COMMONWEALTH of VIRGINIA

October 2, 2006

MEMORANDUM

To: All Holders of the Virginia Department of Transportation's 2001 Road and Bridge Standards

EC-5

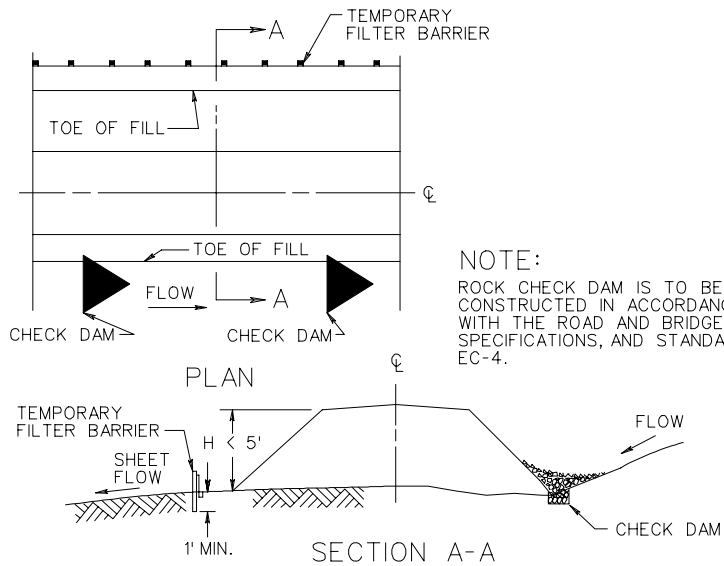
114.06	isd414_1	EC-5	Replaced silt fence at culvert inlet with a check dam.
201.01	a179	CG-2	Revised notes for use of 4" and 6" curb.
201.02	a180	CG-3	Revised notes for use of 4" and 6" curb.

1. IF ANY PORTION OF FILL IS GREATER THAN 5', SILT FENCE IS REQUIRED. IF FILL HEIGHT IS LESS THAN 5', FILTER BARRIER IS REQUIRED.
2. ROCK CHECK DAM IS TO BE CONSTRUCTED IN ACCORDANCE WITH THE ROAD AND BRIDGE SPECIFICATIONS, AND STANDARD EC-4.

WP-2

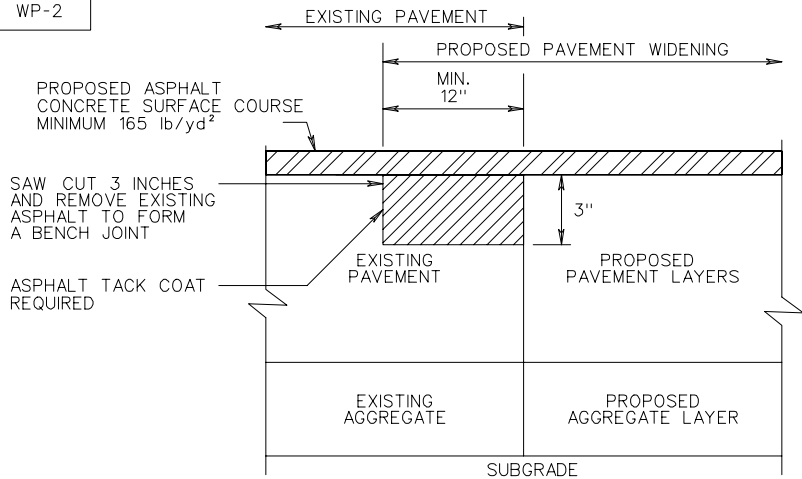
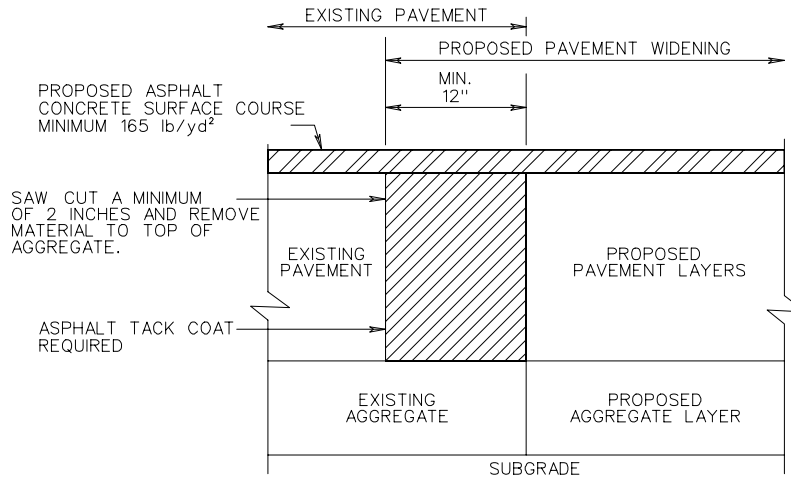
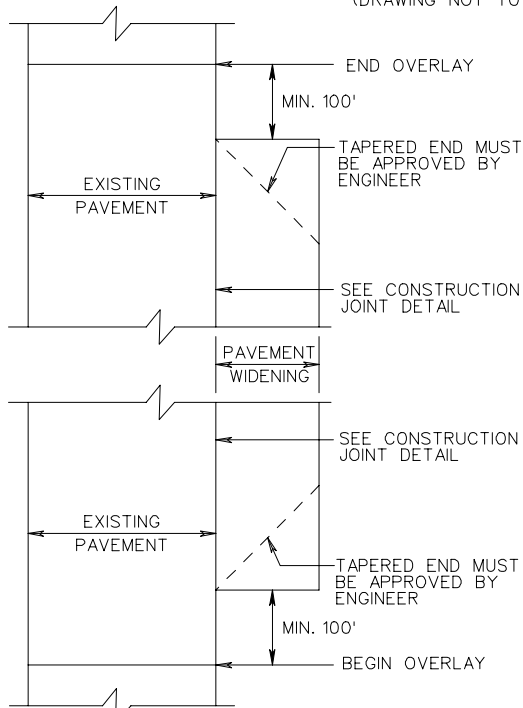
303.02	a187	WP-2	New standard for asphalt pavement widening.
304.03	a188	RS-3	New standard for centerline rumble strips.
305.01	a189	TPT-1	New standard for pavement planing tie-ins.

RW-3

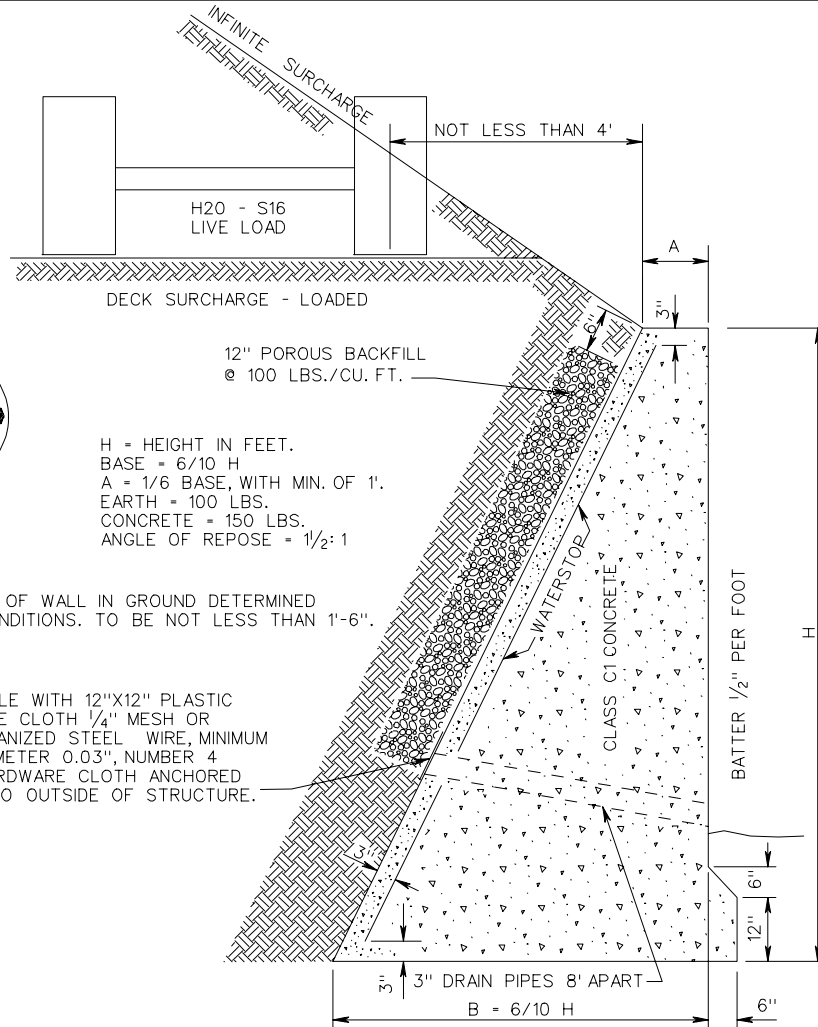
401.02	a161	RW-3	Clarified porous backfill location.
501.05	a87	GR-2, 2A	Added note for GR-11 option in place of 50' of rail with washers

GR-7

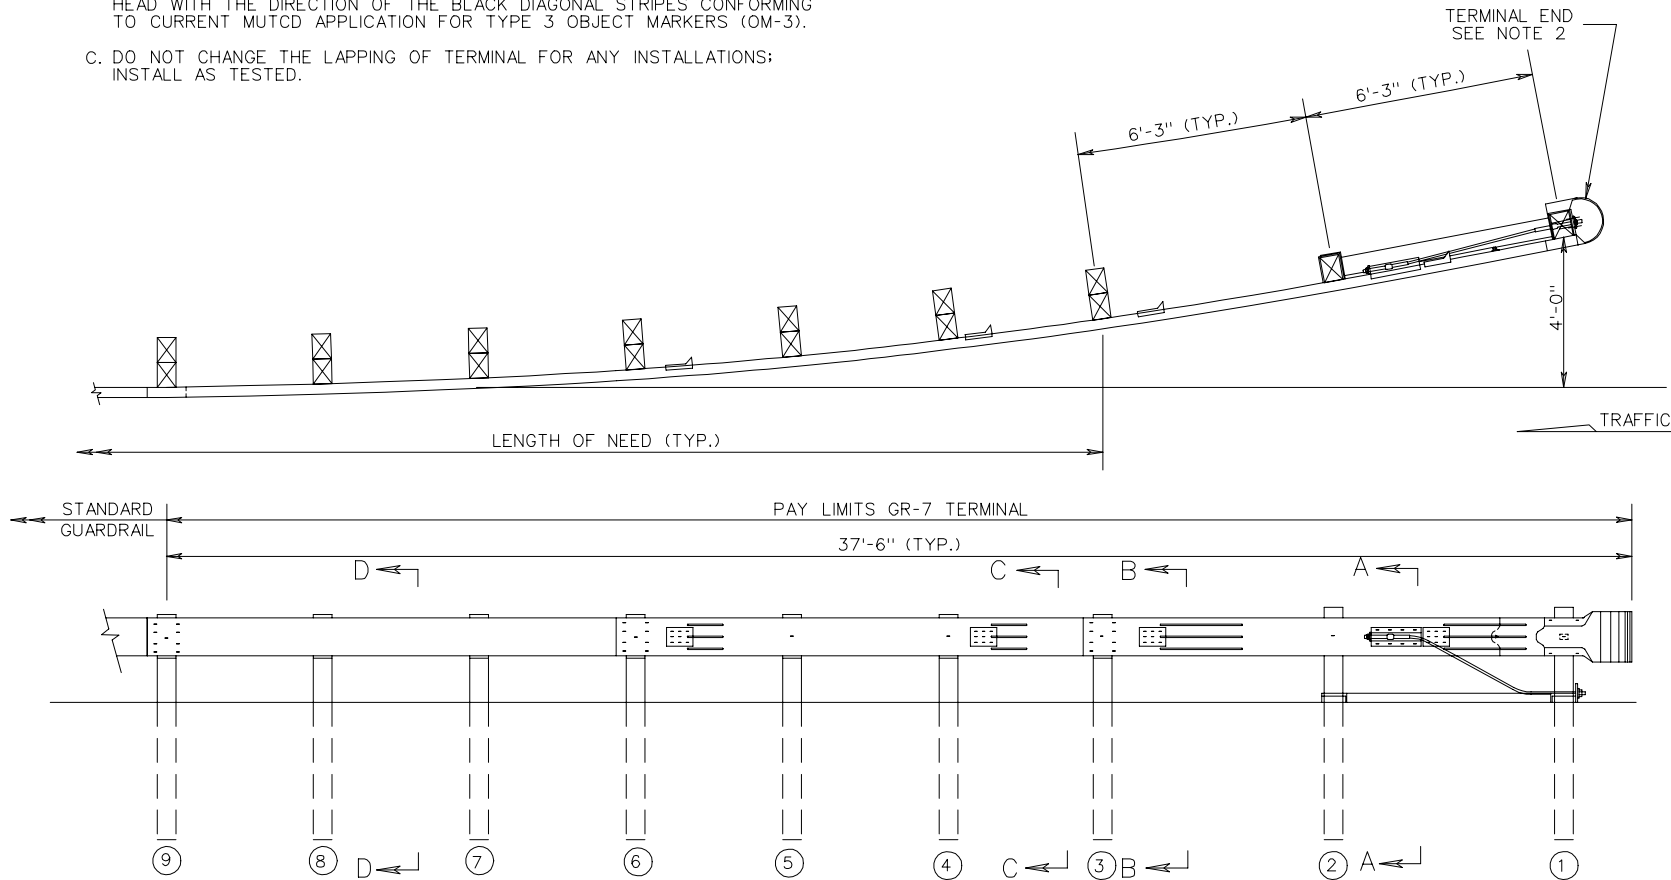
PAGE	INSERT	STANDARD	REVISION
501.11	a89	GR-7	Revised to show only typical dimensions.
501.18	isd2390	GR-9	Revised to show only typical dimensions.
501.19	a88	GR-10	Revised depth of fill above culvert to 4'-0".

GR-10

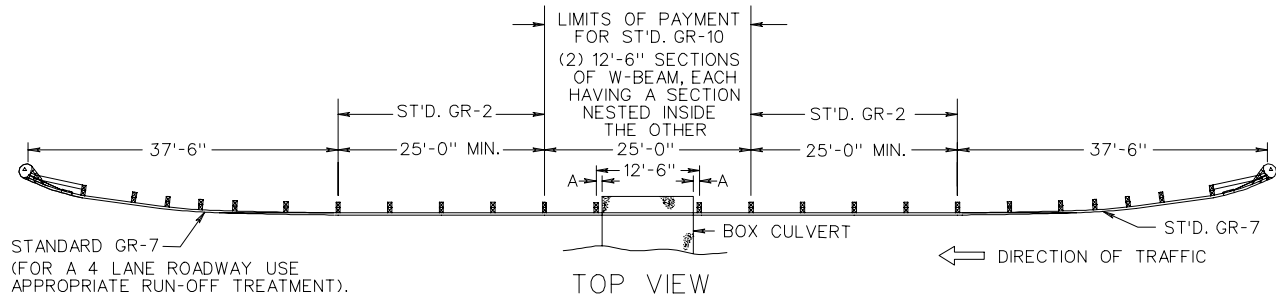
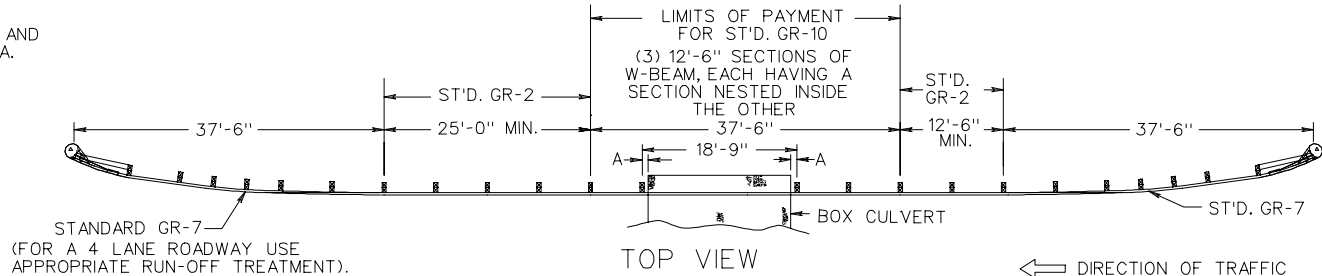
501.20	a88	GR-10	Revised depth of fill above culvert to 4'-0" and added a note about 9" min. distance between post and culvert.
501.25	a65_1	FOA-1	Revised guardrail height to 27 3/4" ± 3/4" to match GR-2.

- NOTES:
1. THIS SHEET IS APPLICABLE WHEN GUARDRAIL IS REQUIRED AND THE DEPTH OF FILL ABOVE THE TOP SLAB OF THE BOX CULVERT IS LESS THAN 4'-0".
 2. GUARDRAIL INSTALLATION SHALL BE IN ACCORDANCE WITH SECTION 505 OF THE SPECIFICATIONS. MATERIAL REQUIREMENT FOR COMPONENTS SHALL BE IN ACCORDANCE WITH SECTION 221 OF THE SPECIFICATIONS.
 3. GUARDRAIL POST SPACING SHALL BE IN ACCORDANCE WITH STANDARD GR-2.
 4. THIS DISTANCE SHALL BE IN ACCORDANCE WITH VDOT POLICY ON DETERMINING THE LENGTH OF NEED FOR GUARDRAIL WITH A MINIMUM DISTANCE AS SHOWN.
 5. ALL SPLICES IN NESTED W-BEAM SECTIONS MUST COINCIDE AT A COMMON POINT AND BE BOLTED TOGETHER USING ONE SET OF BOLTS AT EACH SPLICE.
